Contract #: 04-0120F4Cty: SF/ALA Rte: 80 PM: 13.2/13.9File #: 69.25B**QUALITY ASSURANCE -- NON-CONFORMANCE REPORT****Location:** Changxing Island, Shanghai, PRC**Report No:** NCR-000346**Prime Contractor:** American Bridge/Fluor Enterprises, a JV**Date:** 30-Jul-2009**Submitting Contractor:** Zhenhua Port Machinery Company, Ltd (ZPMC), Changxing Island**NCR #:** ZPMC-0320**Type of problem:****Welding****Concrete****Other****Welding****Curing****Procedural****Bridge No:** 34-0006**Joint fit-up****Coating****Other****Component:** East & South Towers**Procedural****Procedural****Description:** East & South Towers, Lifts 1 & 2**Reference Description:** Heat straightening without prior Engineer approval on East & South Towers**Description of Non-Conformance:**

**Job Name:** SAS Superstructure

**Subject:** NCR No. ZPMC-0320

**Reference Description:** Heat straightening without prior Engineer approval on East & South Towers

**NCR #:** ZPMC-0320

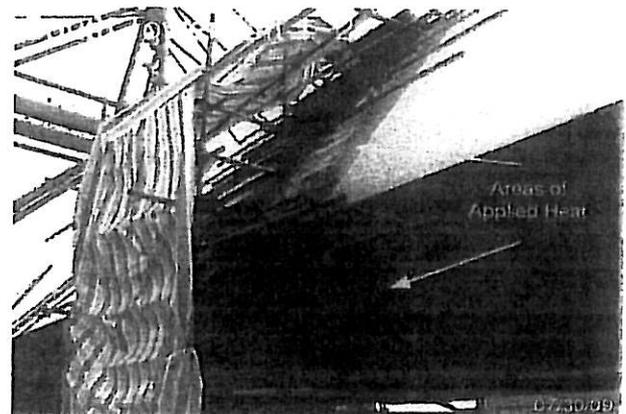
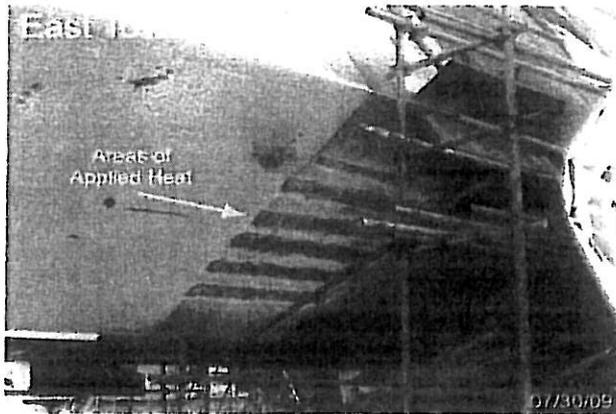
QA observed that ZPMC personnel had performed heat straightening on East and South Towers in a manner not in accordance with the ZPMC Welding Quality Control Plan (WQCP). Heat straightening procedures not outlined in the WQCP require prior Engineer approval.

WELDING QUALITY CONTROL PLAN	SECTION 11
	San Francisco Oakland Bay Bridge Project	PAGE: 7 OF 17 REV. 0 July 2007

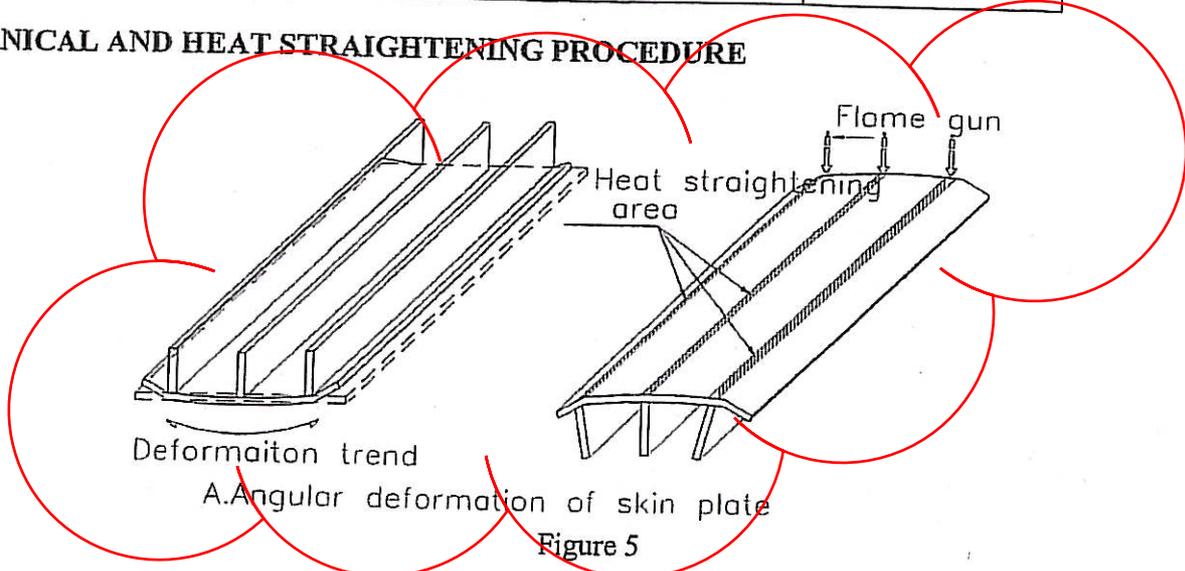
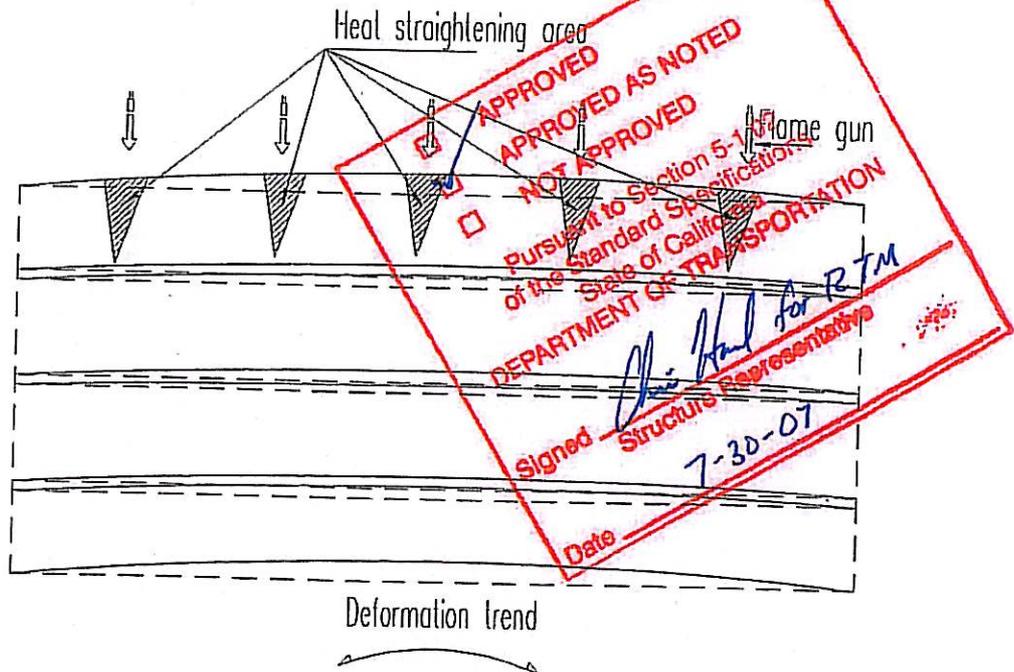
The Department disagrees that the procedure described in Section 11.2.6.4 of the WQCP (page 7 of Section 11 per the attachment) is still valid when the shaft is assembled. Section 11.2.7 of the WQCP approved on 10/26/07 specifies that the techniques and procedures to be applied to correct distortion of the tower section after welding that are different than ones that ZPMC used. It should also be pointed out that ZPMC submitted HRS(T)-210 and 211 for Heat Straightening of South Shaft Lifts 1 and 2 utilizing the method observed in NCR ZPMC-0320.

**Reference Resolution:** To clarify, ZPMC was performing heat straightening in accordance with the procedure on page 7 of Section 11 of the WQCP to correct angular distortion of the skin plate.
